SUBJECT: Forwards info re leakage rate specs to be used for 10CFR50
 App J MSIV leak testing & acceptability of ball valves, in
 response to NRC concerns, MSIV cutaway diagram encl.

Re: Nine Mile Point Unit 2
Docket No. 50-410

Issue

FIGURE 5.4-7

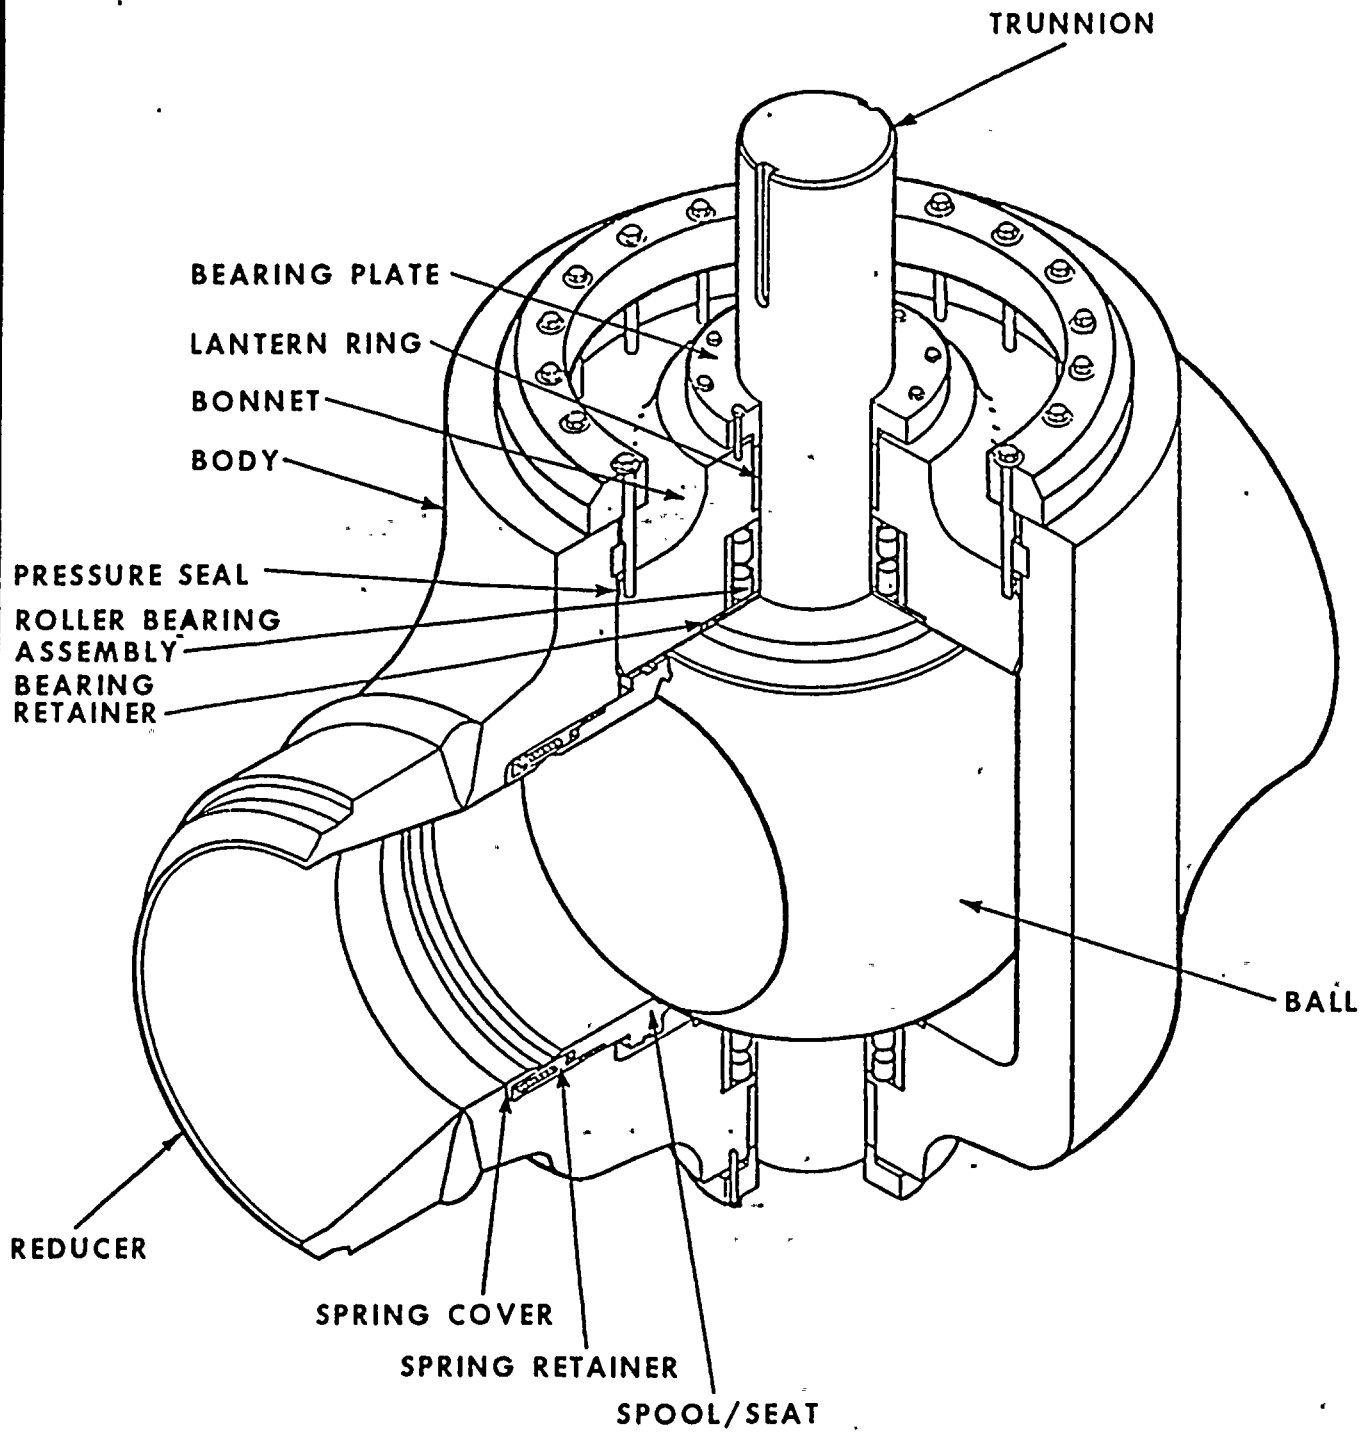
The NRC indicated that the Nine Mile Point Unit 2 main steam isolation valve leakage was a potential concern. The NRC indicated that information should be provided to the staff regarding the leakage rate specifications to be used for 10CFR50 Appendix J leak testing and information regarding the acceptability of the ball valves.

The Nine Mile Point Unit 2 ball valves were specifically selected because of their low leakage rate criteria. The attached figure is a breakdown diagram of the ball valves showing one of the two sealing surfaces which provide superior leakage control. Recently, Nine Mile Point Unit 2 has provided a 10CFR50.55(e) report which indicated that based on experience at the Liebstadt plant, a potential problem developed which could increase the leakage of the ball valve. To resolve this issue, Liebstadt did a spool bore modification to restore the superior leakage capability of the valves. Subsequently, Liebstadt has gone into commercial operation. Based upon a telephone conversation with members of the technical staff at the Liebstadt plant, we have determined that the ball valves have successfully passed leakage tests and showed an average leakage of less than 1.25 scfh per hour with an applied pressure of 15 psig across each seat. This demonstrates the superior design of the valve.

At the present time, a spool bore modification is in progress for the Nine Mile Point Unit 2 project. This consists of boring out the existing spool bore and cladding the area with Inconel to provide a corrosion resistant surface. This modification is expected to provide superior long term leak tight integrity.

The proposed leakage rate specification (in the Technical Specification) for the main steam line isolation valves has been determined to be 5.5 scfh (at standard conditions of 14.7 psia and 68°F) per valve at test conditions of 40 psig and 80°F. This leakage rate, based upon our calculations, ensures that offsite dose releases and control habitability criteria of 10CFR100 and General Design Criterion 19 of 10CFR50 are met, respectively. This leakage specification is based on leakage through both the upstream and downstream seats. These valves, however, are leak tested by pressurizing between the

seats. When testing the valves this way, measured leakage rate of 15.6 scfh corresponds to a leakage rate of 5.5 scfh across both sets of seats. Additionally, the leakage acceptance criteria for a single mainsteam isolation valve can be increased provided that the total leakage for all lines remains below the allowable leakage rate. For example, the offsite releases and control room dose are still within the acceptable values if the measured leakage rate for a MSIV was 17 scfh (when pressurizing between the seats), when the remaining seven valves meet a measured leakage rate of less than 14 scfh.
